FINAL MITIGATION PLAN
Harrell Mitigation Site

Jackson County, NC
Project Number: 100005
Contract Number: 7006
RFP: 16-006811

Reference: Harrell Site Draft Mitigation Plan

Re: NCIRT Review and USACE Approval of the Harrell Stream and Wetland Mitigation Plan; SAW-2016-02202; NCDMS Project # 100005

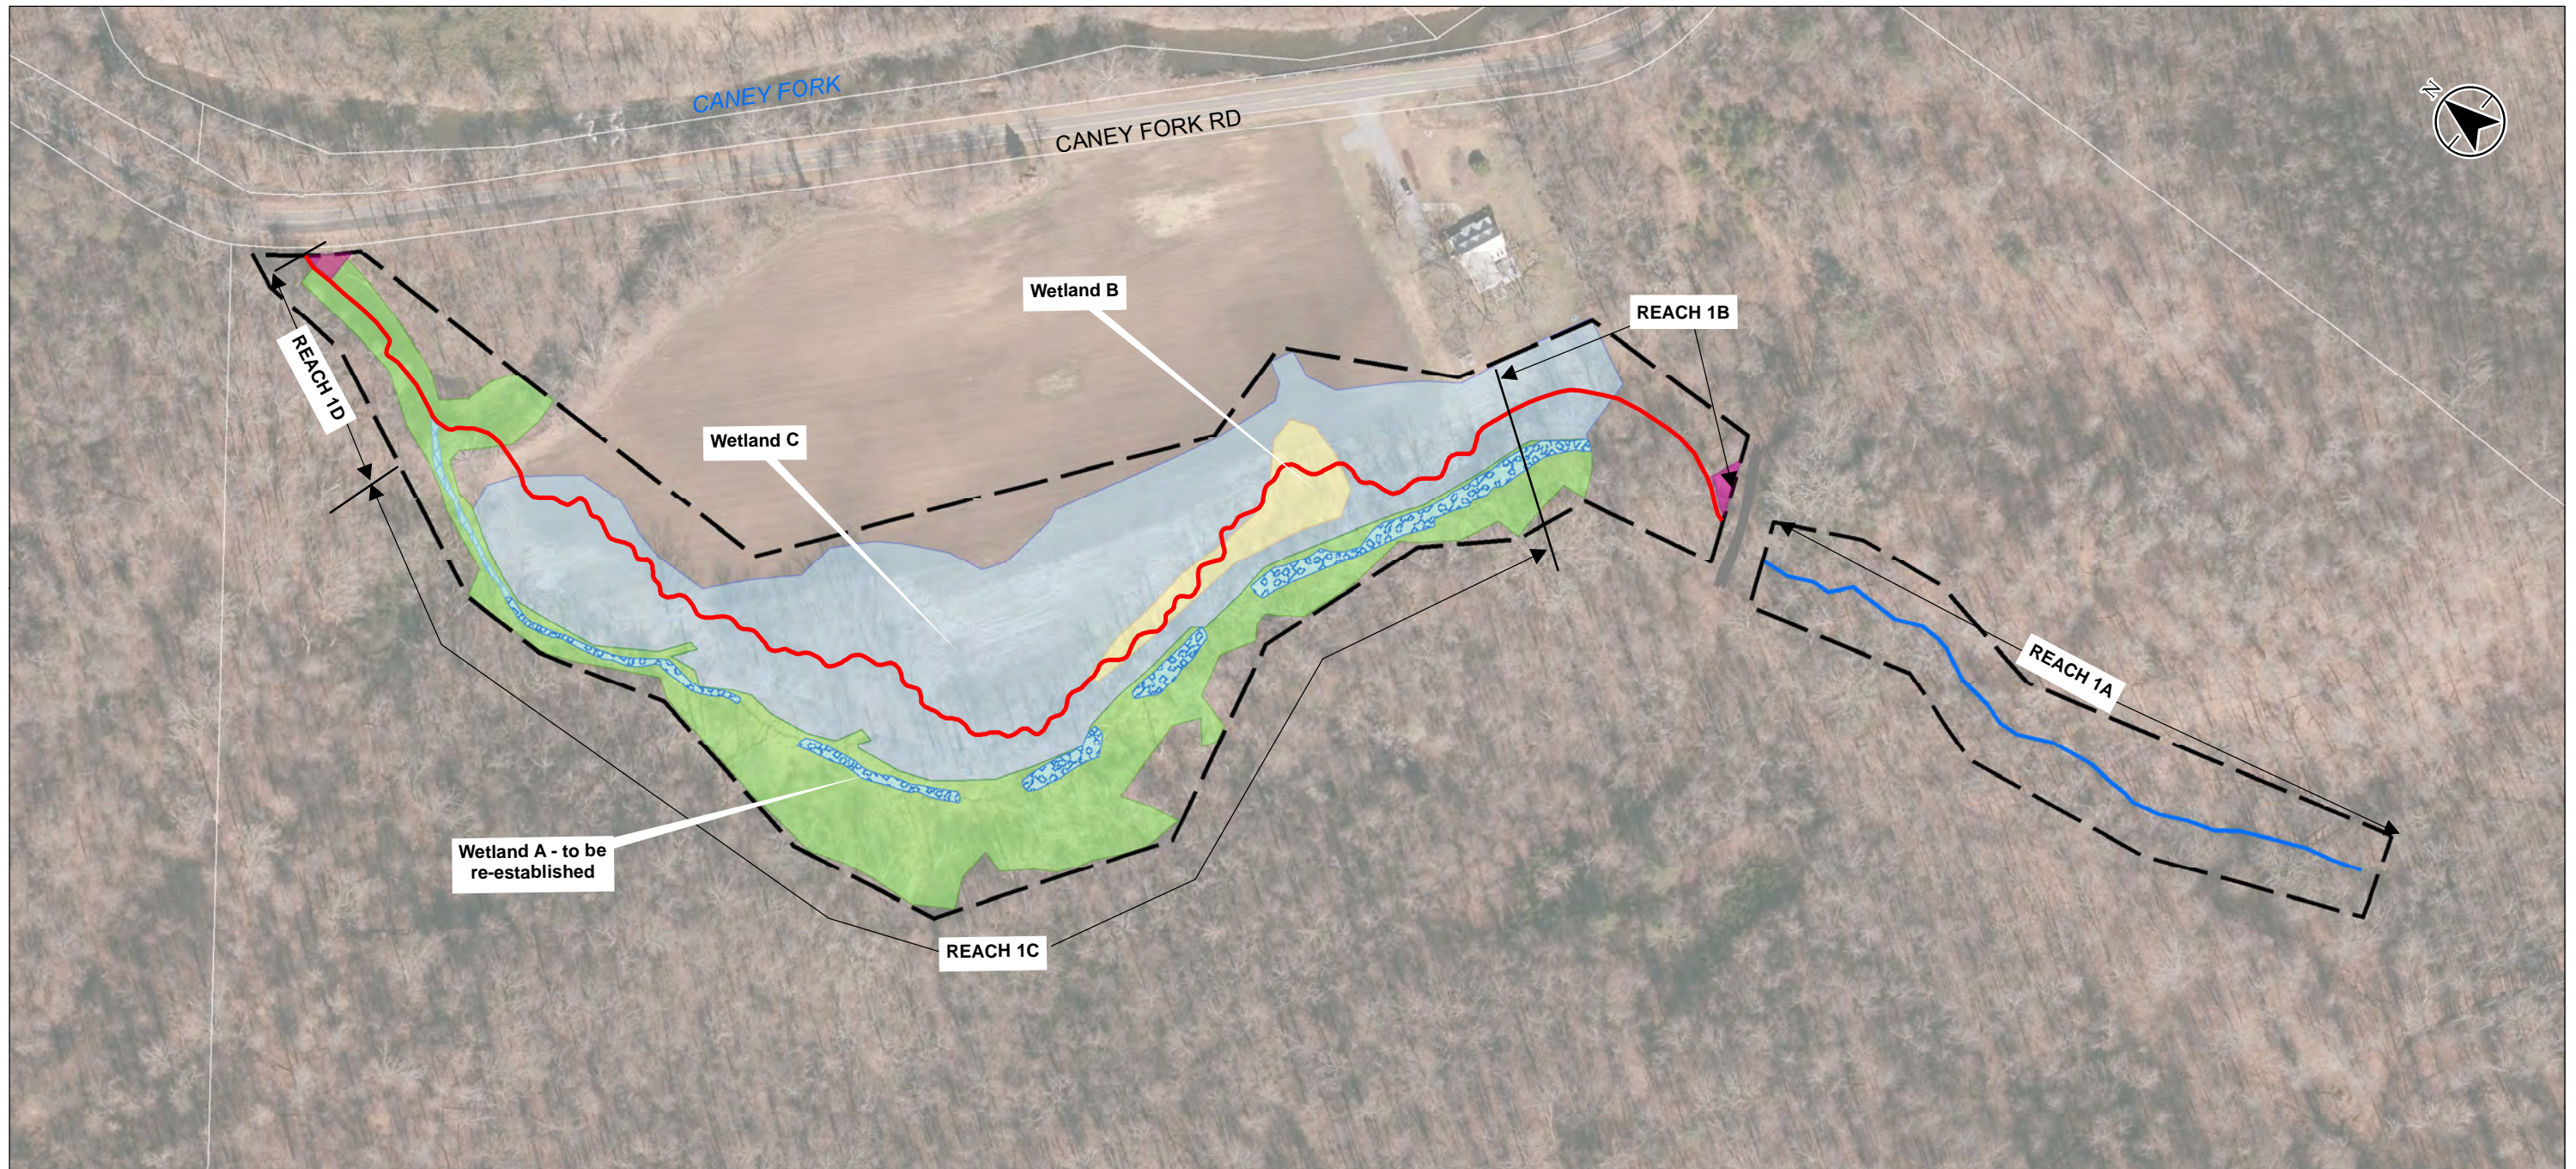
Comment: Lastly, the Asset map (Figure 4) and Proposed Monitoring Map (Figure 5) do not show these community types. Each community type should be represented by at least a single vegetation monitoring plot.

Response: Figures 4 and 5 have been updated to show each community. Only small areas within the Piedmont/Mountain Semi permanent Impoundment community, near the existing channel, will be planted due to construction activities. Vegetation plots that have been selected are representative of the natural communities at the site that will be planted.

Revision Sheet: 0 9

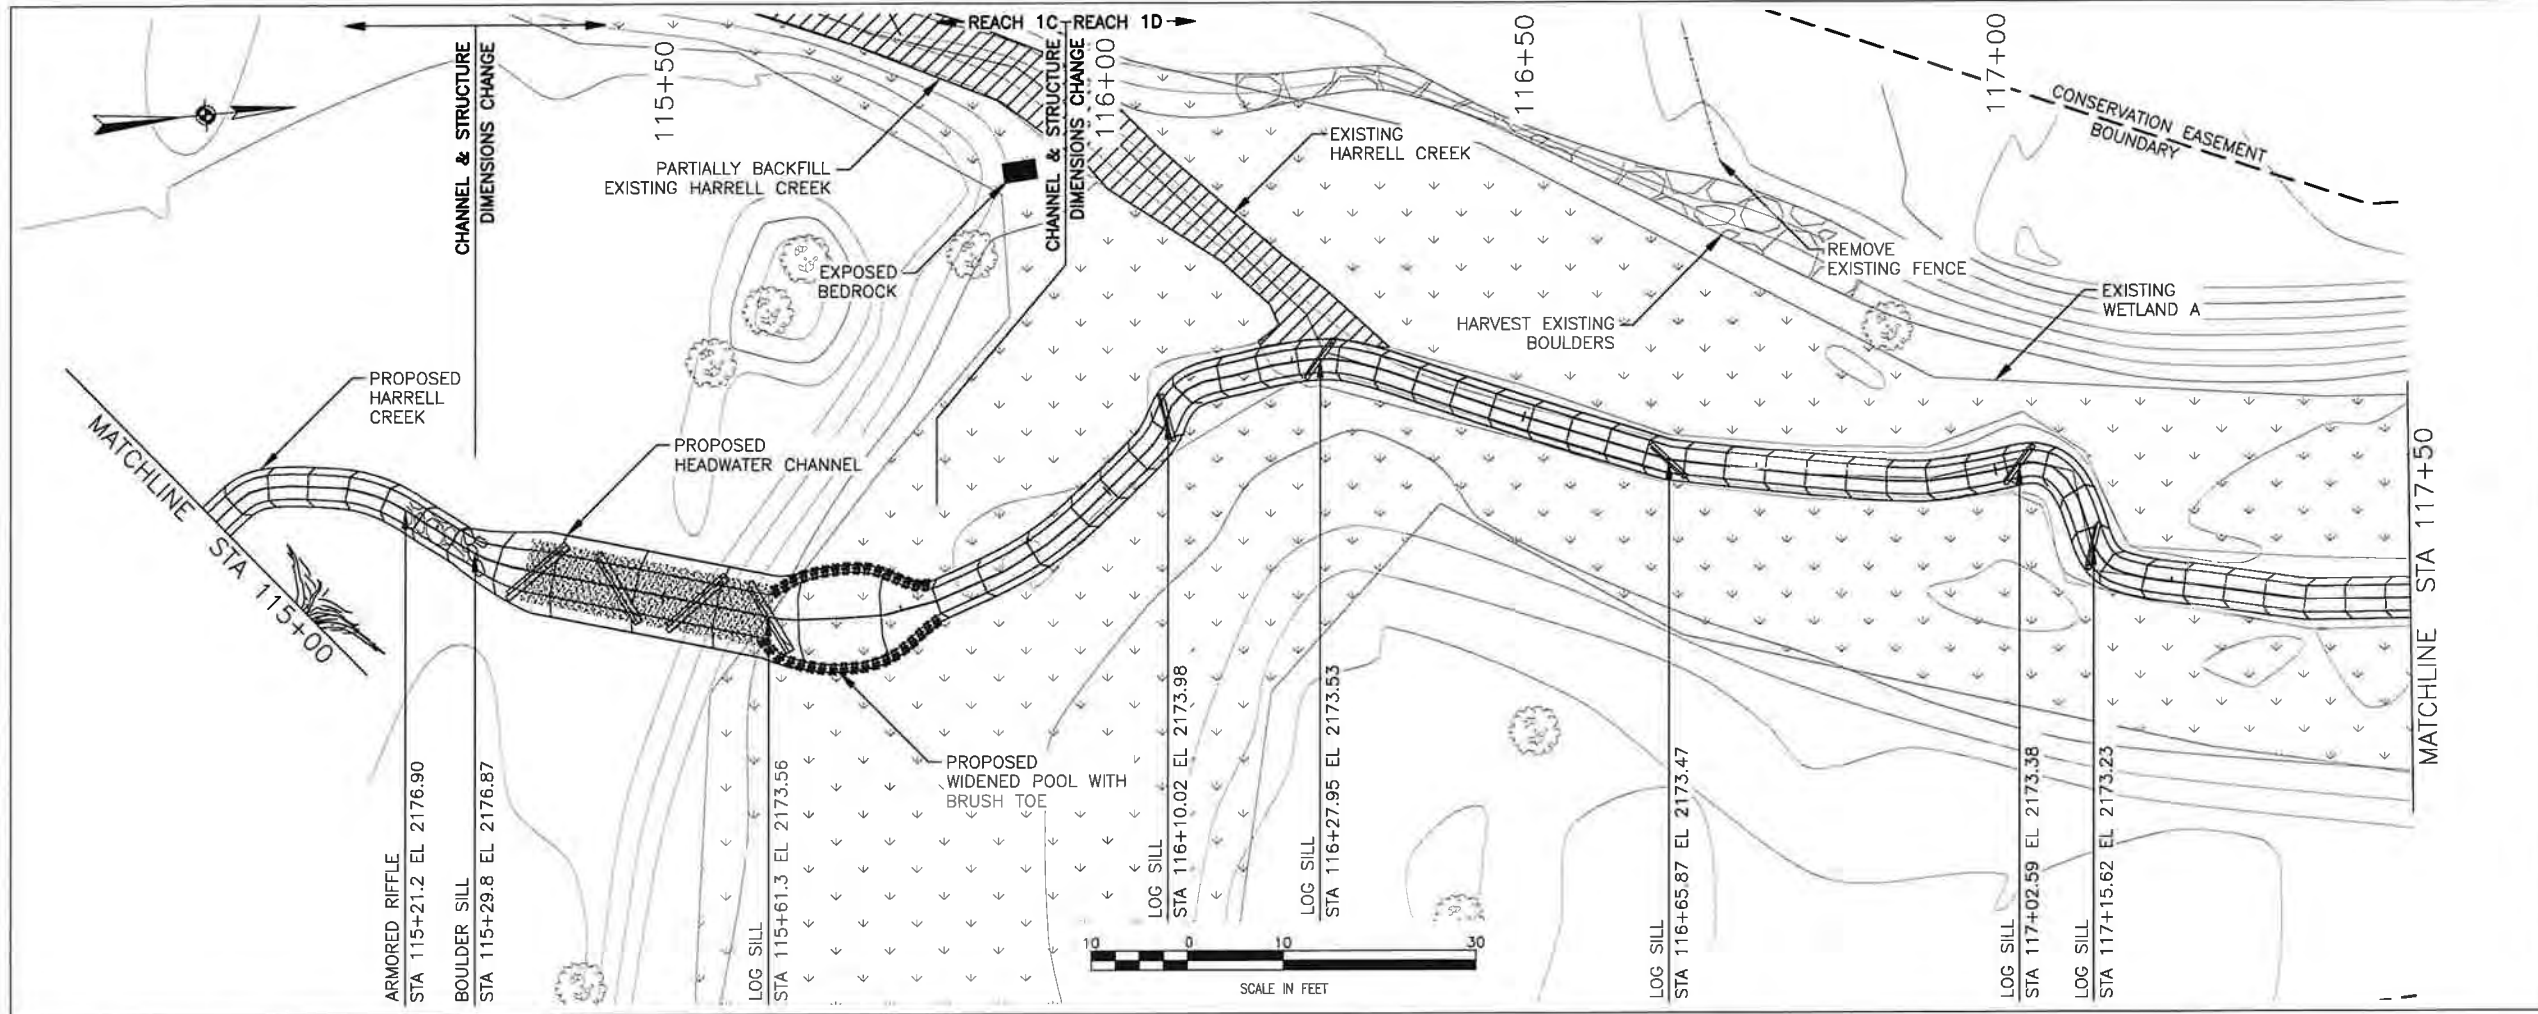
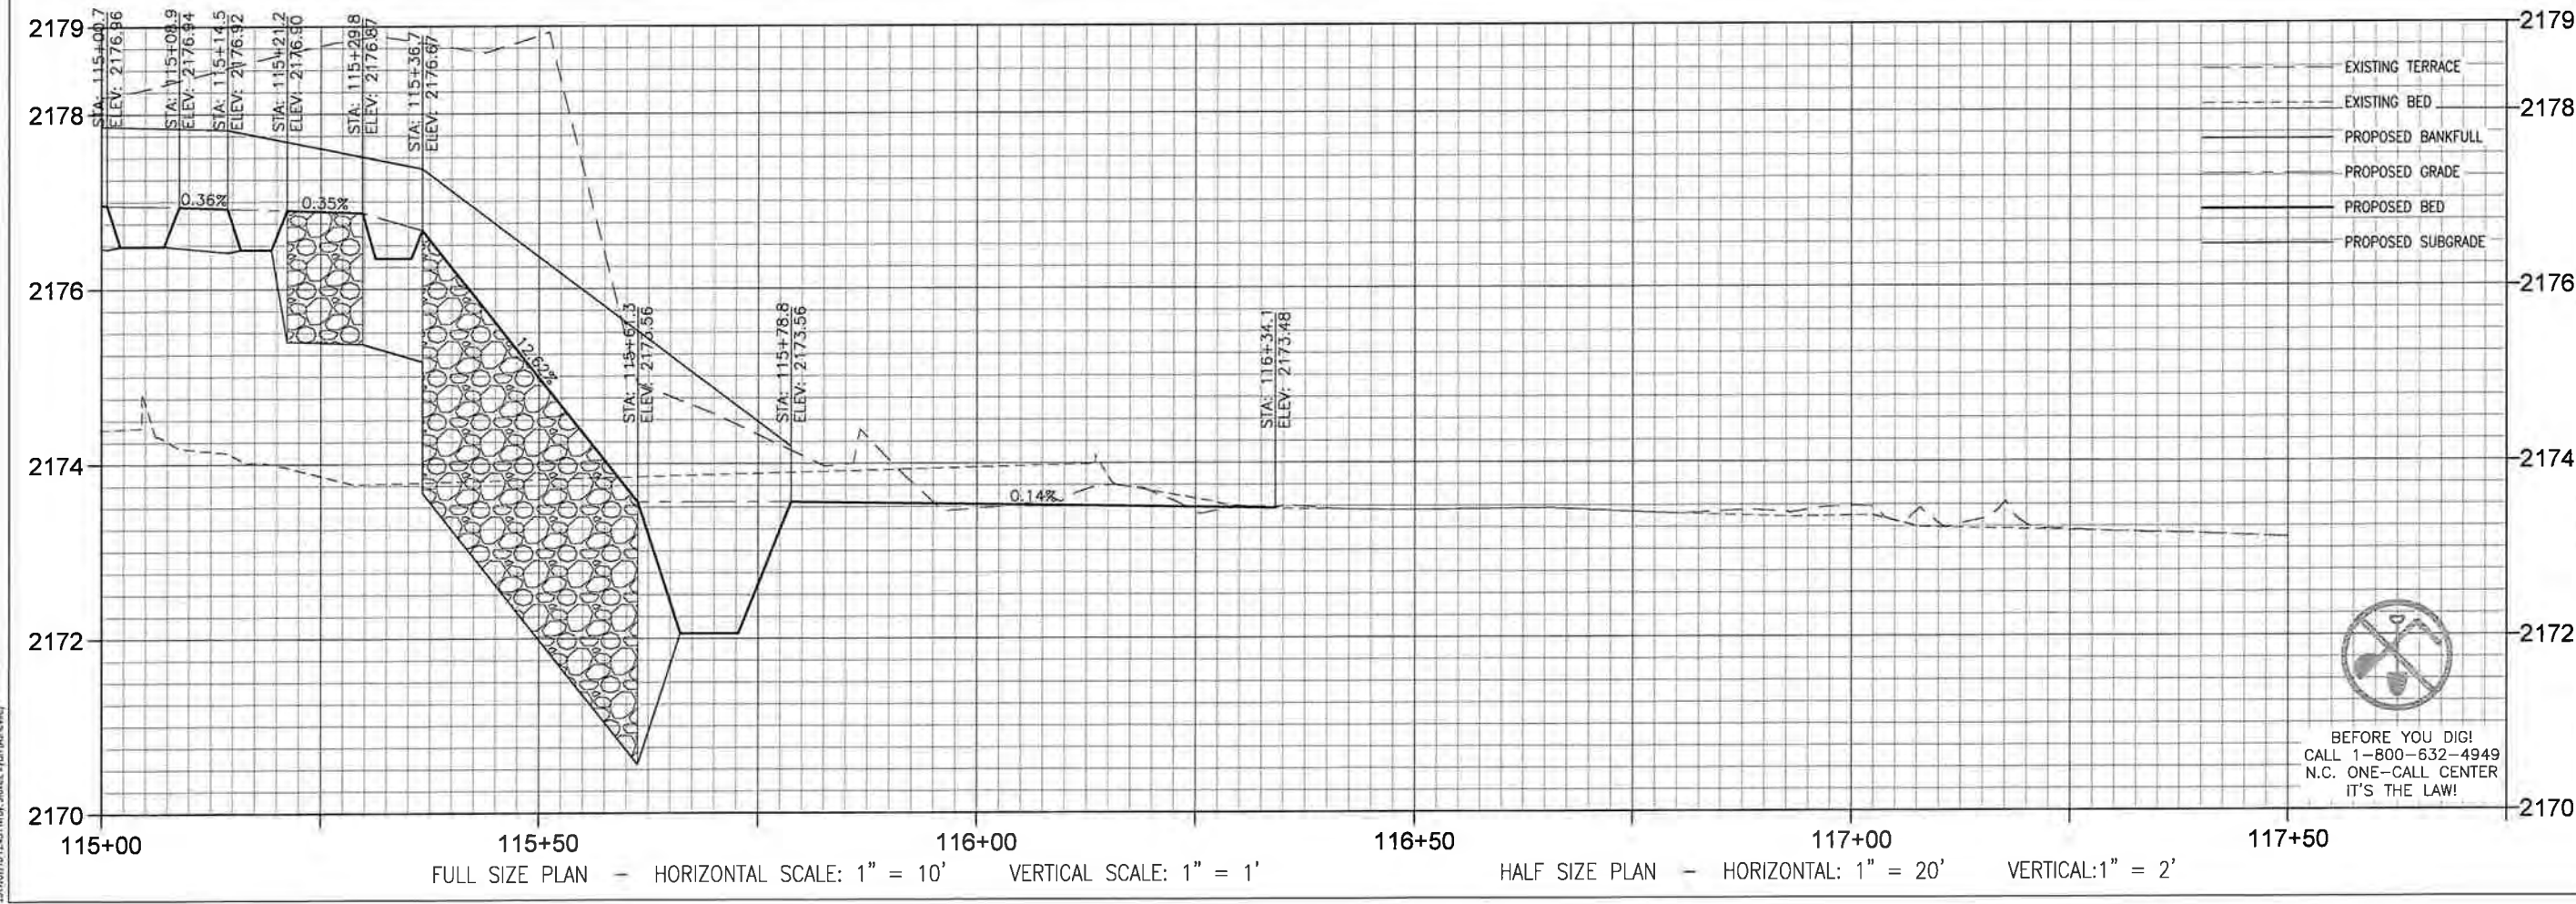
Comment: Rather than a crest gauge, as proposed in Table 19, DWR would like to see a stream gauge placed in the stream at station 113+00 (sheet 9, design sheets).

Response: A stream gauge (continuous stage recorder) will be placed in the stream for use as a crest gauge.
